SUBJECT: NuScale Power, LLC Supplemental Response to NRC Request for Additional

Information No. 249 (eRAI No. 9135) on the NuScale Design Certification

NuScale Supplemental Response to NRC Request for Additional Information eRAI No. 9135

NRC Question No.: 14.03.03-5

NUSCALE SAFETY-RELATED CONTAINMENT ISOLATION VALVE ITAAC

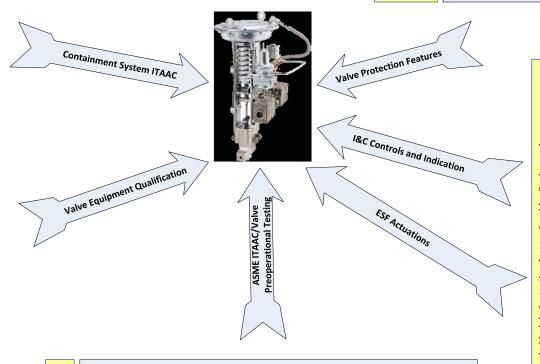
As an example of NuScale's safety-related valve ITAAC, the attached diagram describes the population of as-built inspection ITAAC and preoperational test ITAAC required for each containment isolation valve which is a safety-related valve. Note that the implementation of the listed ITAAC requires each containment isolation valve to be inspected or tested twenty-five times.
